2.15 Structures and Servicing Systems

The information in this section of the reference ABWR DCD, including all subsections, tables, and figures, is incorporated by reference with the following departures.

Figure 2.15.5e Reactor Building Safety-Related Equipment HVAC System

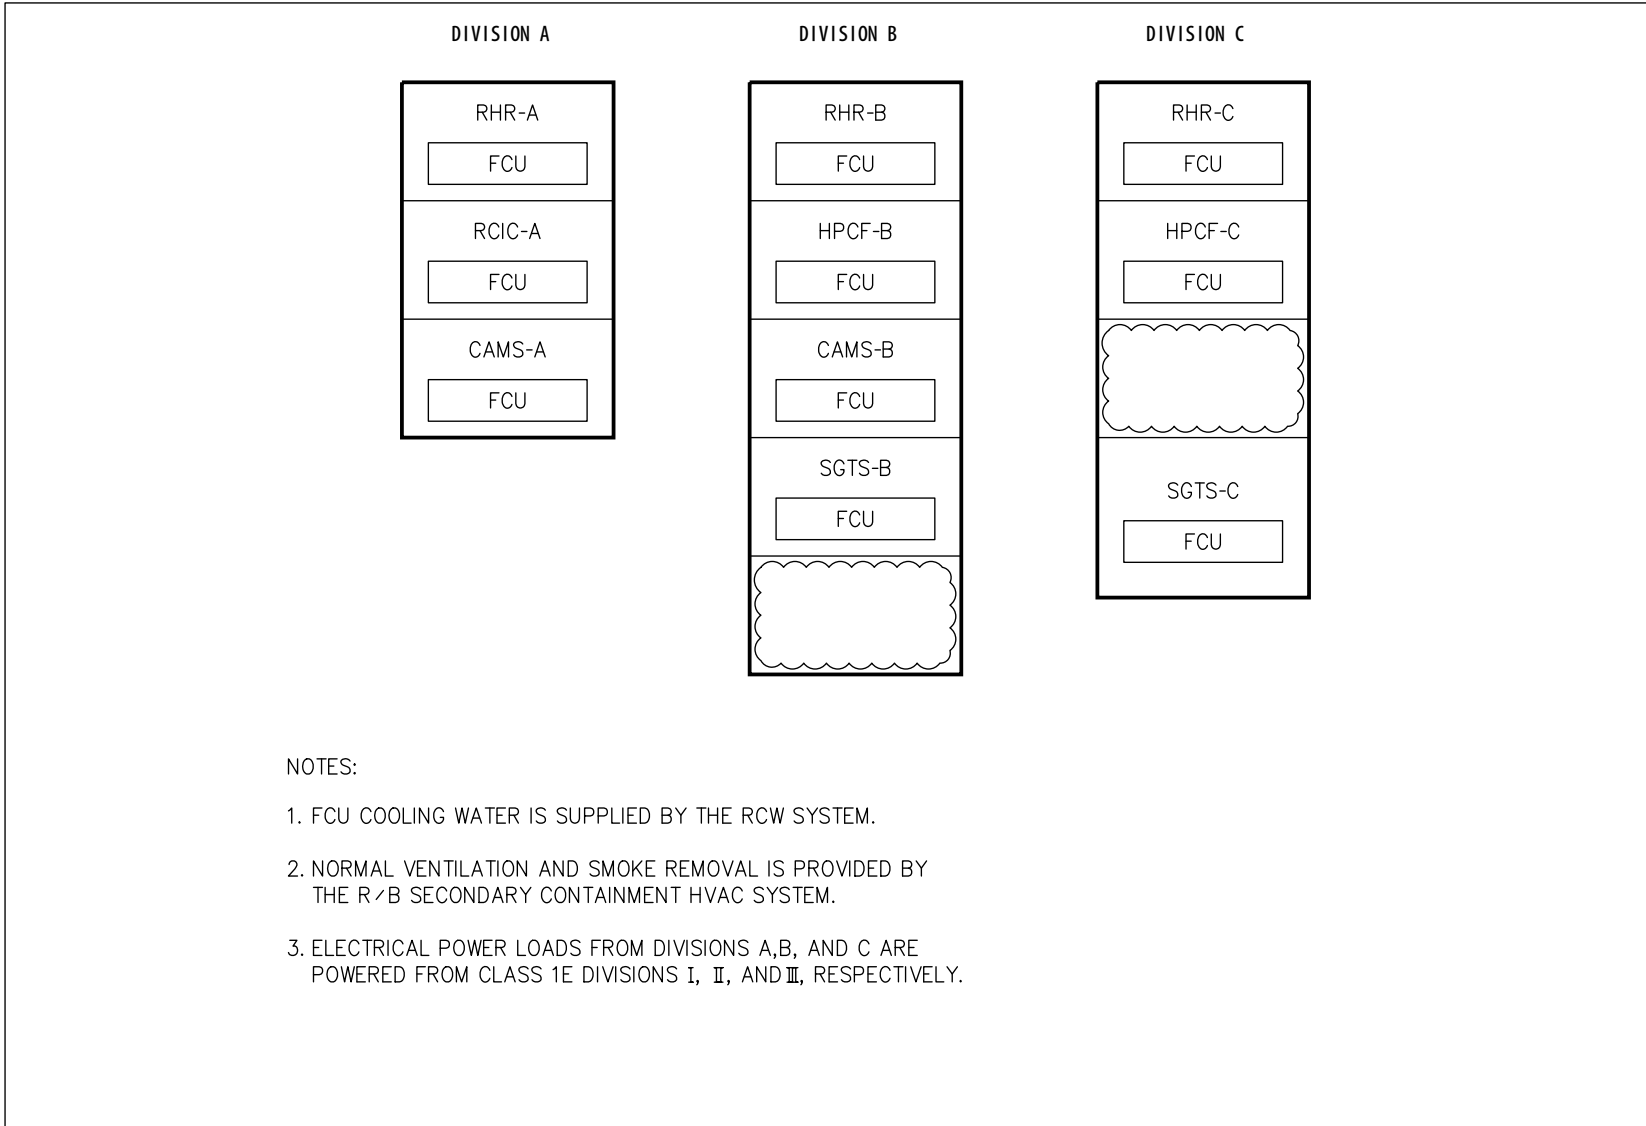
STD DEP T1 2.14-1 ([Figure 2.15.10a](#), [Figure 2.15.10j](#), [Figure 2.15.5e](#), [Table 2.15.5c](#))

The R/B Safety-Related Equipment HVAC System provides cooling of safety-related equipment areas, and consists of independent fan coil units. Figure 2.15.5e shows the basic system configuration and scope.

The Residual Heat Removal (RHR) System, High Pressure Core Flooder (HPCF) System and Reactor Core Isolation Cooling (RCIC) System pump room FCUs are automatically initiated upon startup of their respective room process pump. The Containment Atmospheric Monitoring System (CAMS) and Standby Gas Treatment System (SGTS) room FCUs are automatically initiated upon isolation of the Reactor Building Secondary Containment HVAC System. ~~The Flammability Control System (FGS) room FCUs are also initiated upon a manual FGS start signal.~~
